**CITY OF MERIDIAN
FINDINGS OF FACT, CONCLUSIONS OF LAW
AND DECISION & ORDER**

Case No(s). H-2026-0001

COMMUNITY DEVELOPMENT DEPARTMENT REPORT

SUBJECT: H-2026-0001
Skybreak Rim MDA, PP, RZ

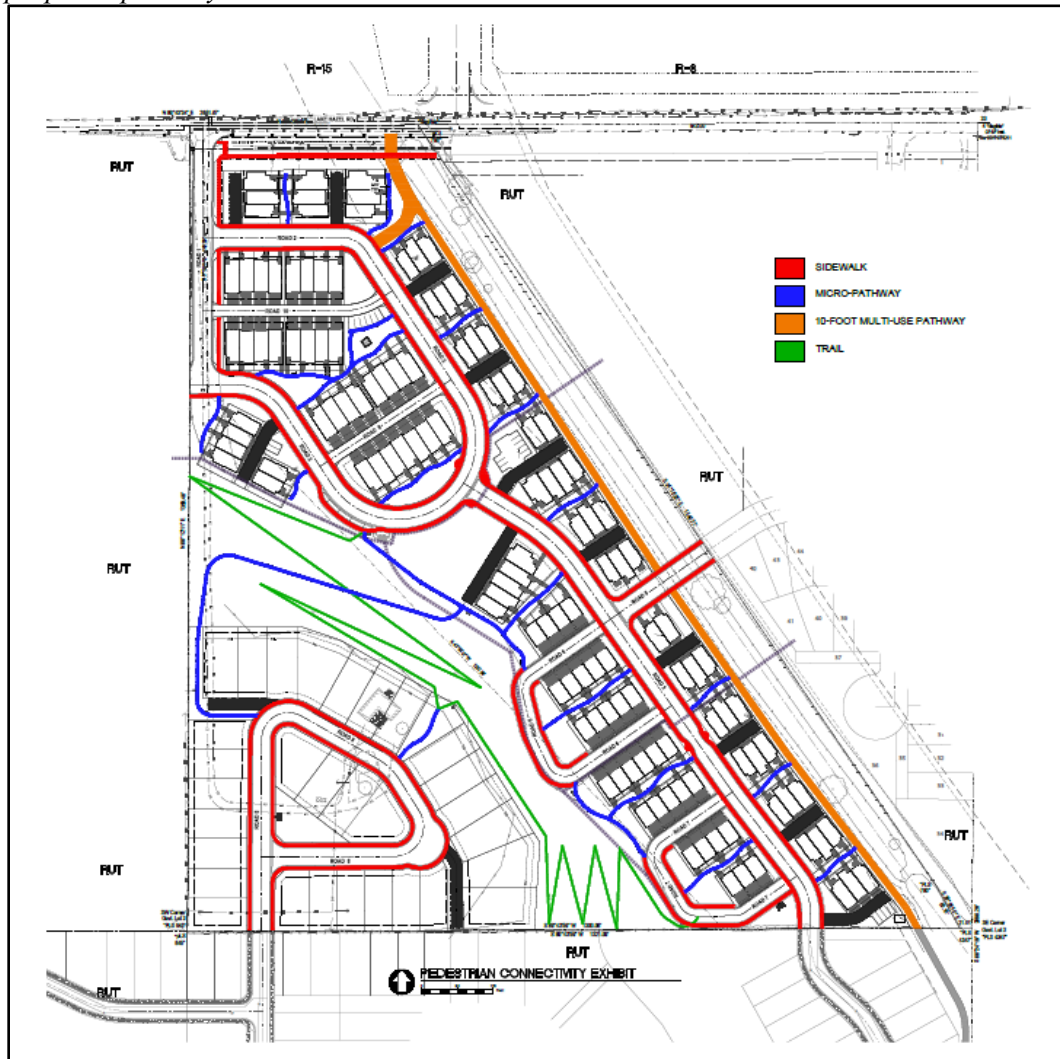
The applicant is proposing a pathway on the north side of the property that connects to a foothill trail descending the slope. This trail will be designed as a natural switchback along the hillside, with disturbed areas reseeded and maintained in a natural condition. In addition, a separate pathway is proposed within the open space area along the private road. This pathway is standalone and does not directly connect to existing sidewalks or other pathway systems.

The applicant needs to update their pedestrian circulation exhibit to show how they plan to connect the proposed pathway below the slope to Pura Vita Subdivision.

Pedestrian Connectivity Exhibit

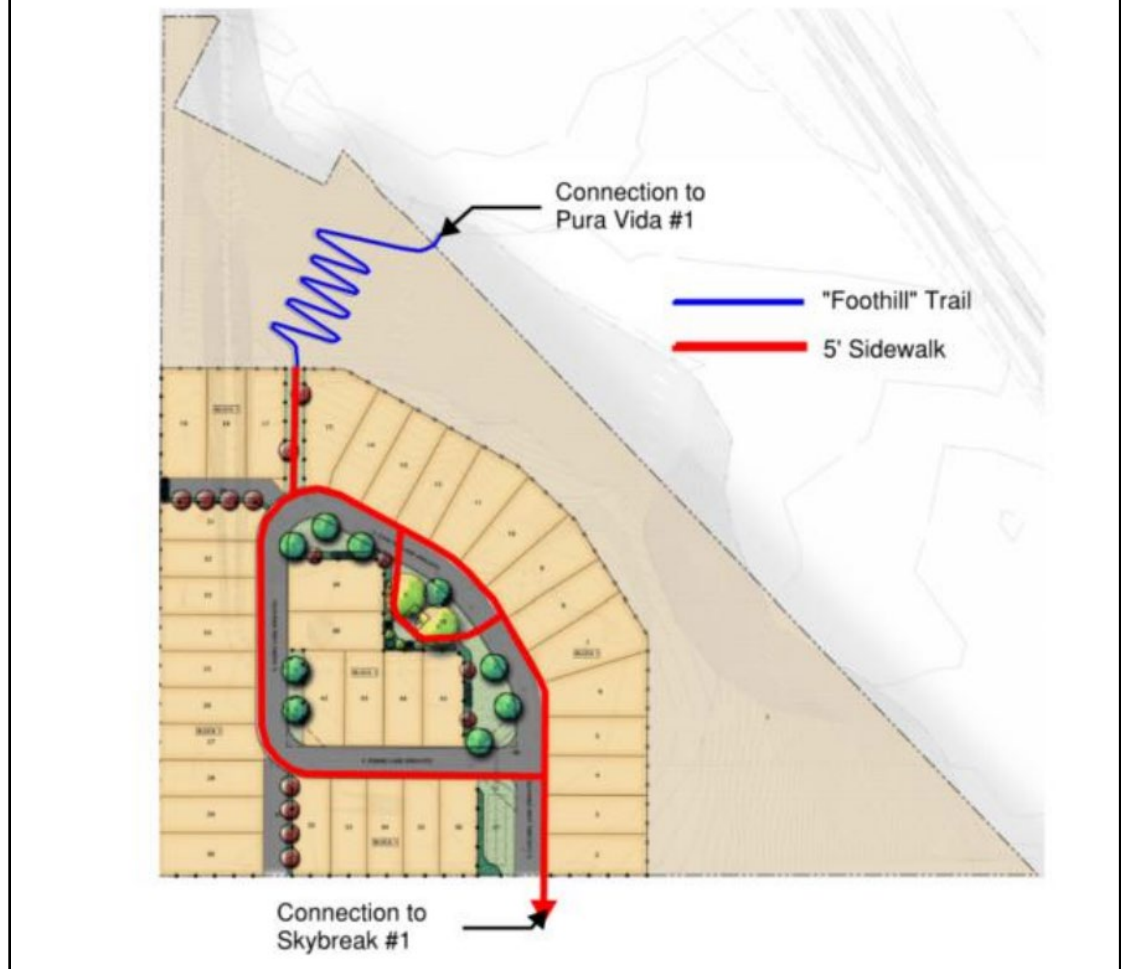
The applicant is proposing a private street with a 5-foot sidewalk on the east side which does not meet the requirements of UDC 11-3F-4.C.2.b. The applicant is requesting a waiver to design the same street section and sidewalk configuration approved with the original Skybreak Subdivision (see exhibit below).

As the private street section of the UDC was changed in 2025, the Planning Commission and City Council should carefully consider whether the proposed request meets the intent of the current UDC for sidewalks associated with private streets.

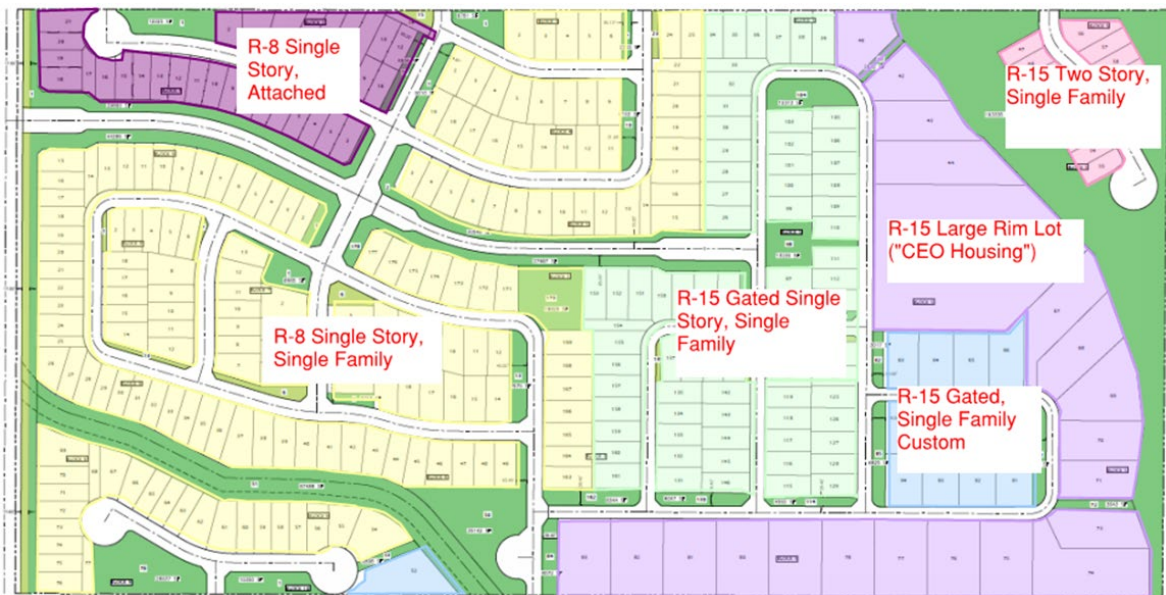
The applicant is required to comply with the private street requirements outlined UDC 11-3. To serve the 38-lot development the applicant is proposing private streets. In doing so, they are proposing to utilize the existing private street network within the Skybreak development. While the proposed subdivision does not include additional gates, the development will connect to and rely on the existing private streets and gated entrances that currently serve the Skybreak community.

The City Council previously approved the Skybreak development with 106 homes served by private streets and two (2) gated accesses. The current proposal would add an additional 38 homes to the private street network.
